AMERICAN SUZUKI MOTOR CORPORATION

07V-515  
(19 pages)

<p><b>SAFETY RECALL CAMPAIGN #2099 ALL 2004 - 2007 GS500FK4-K7 MODELS REAR FENDER REFLECTOR REPLACEMENT</b></p>
---

**SAFETY RECALL CAMPAIGN #2A01  
ALL 2002 - 2007 GZ250K2-K7 MODELS  
REFLECTOR SET REPLACEMENT**

Figure 1

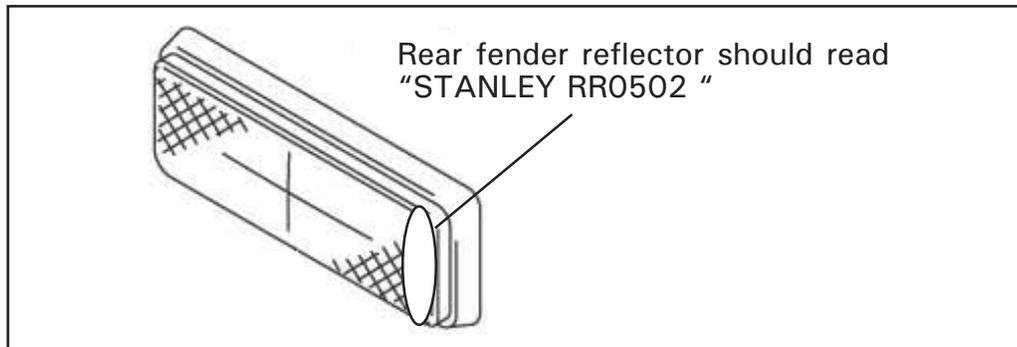
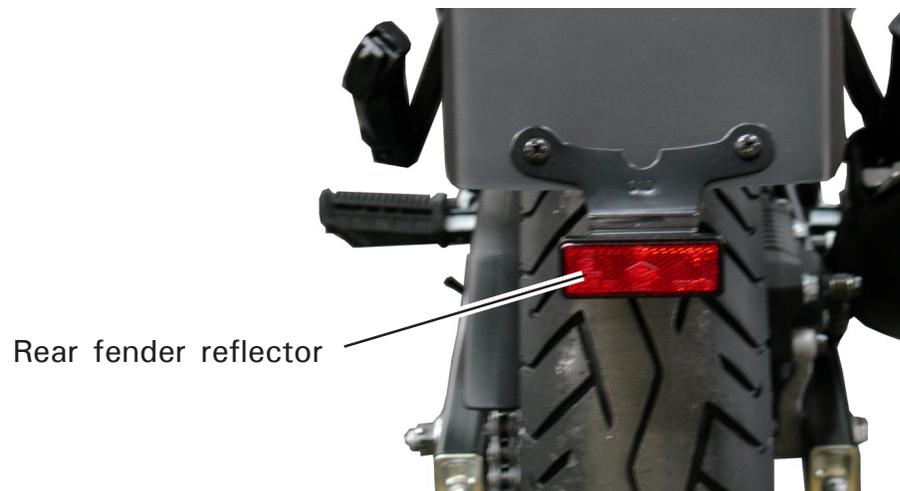
1. Check the repair status by checking the Vehicle History in the Suzuki Connect Service Menu. If the repair needs to be performed to the motorcycle, you will see the message "CAMPAIGN NOT YET PERFORMED" displayed and the rear fender reflector will need to be replaced. Refer to the replacement procedure in this bulletin.
2. Inspect the manufacturer identification markings on the rear reflector. If the name "STANLEY RR0502" is present (refer to Figure 1 on page 3) the recall repair has already been performed.

1. Remove and replace the rear fender reflector using the preexisting nut.

Figure 1

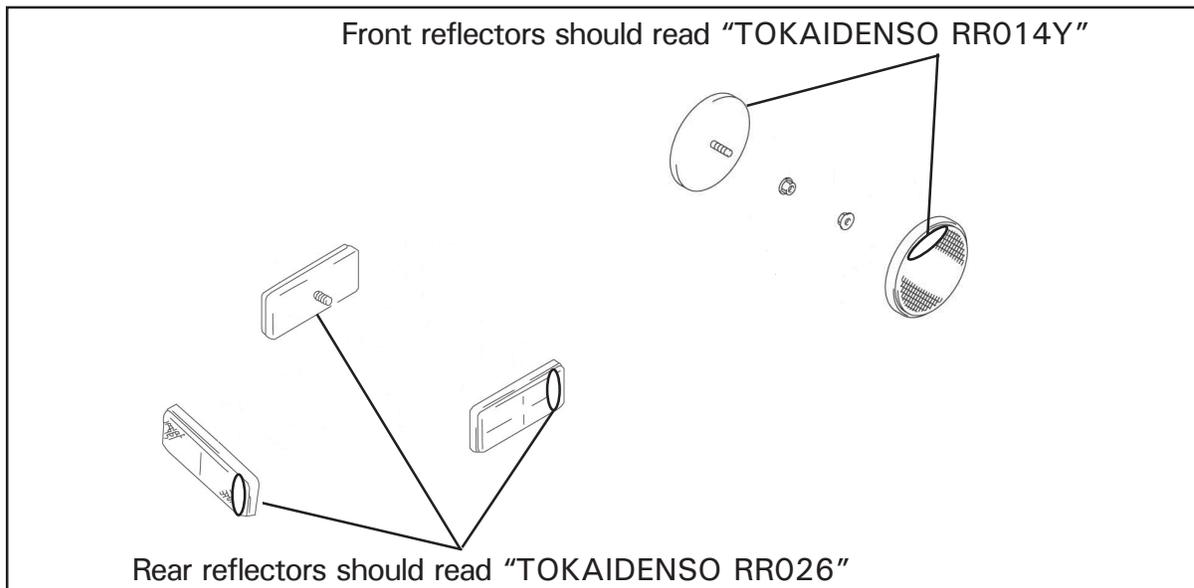
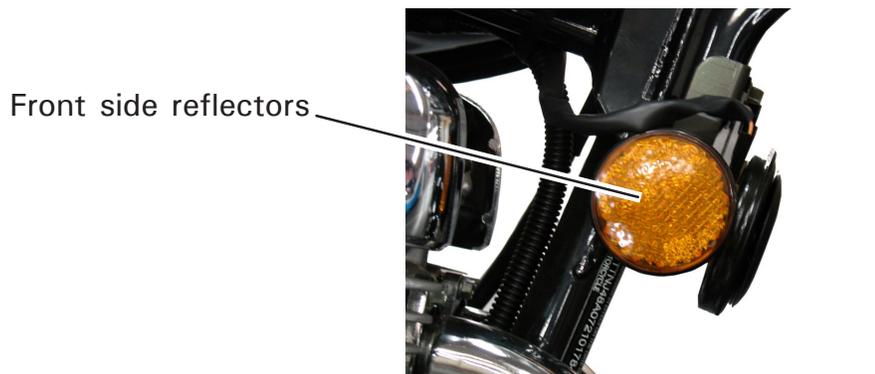
1. Check the repair status by checking the Vehicle History in the Suzuki Connect Service Menu. If the repair needs to be performed to the motorcycle, you will see the message "CAMPAIGN NOT YET PERFORMED" displayed and the front and rear reflectors will need to be replaced. Refer to the replacement procedure in this bulletin.
2. Inspect the manufacturer identification markings on the front and rear fender reflectors. If the name "TOKAIDENSO RR014Y" is present on the front side reflectors and "TOKAIDENSO RR026" is present on the rear side and rear fender reflectors (refer to Figure 1 on page 3) the recall repair has already been performed.

1. Remove and replace the front side reflectors using the replacement nuts provided in the Reflector Kit.

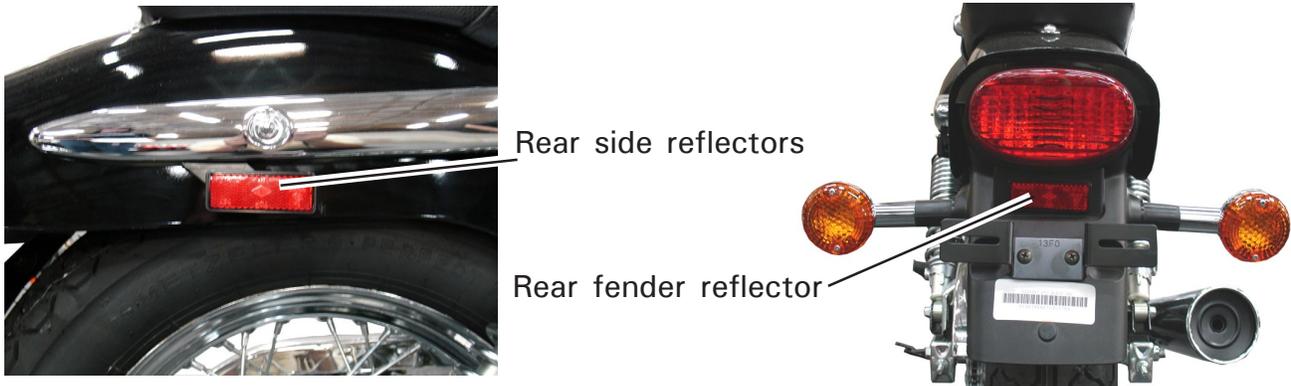
2. Remove and replace the rear fender and rear side reflectors using the preexisting nuts.
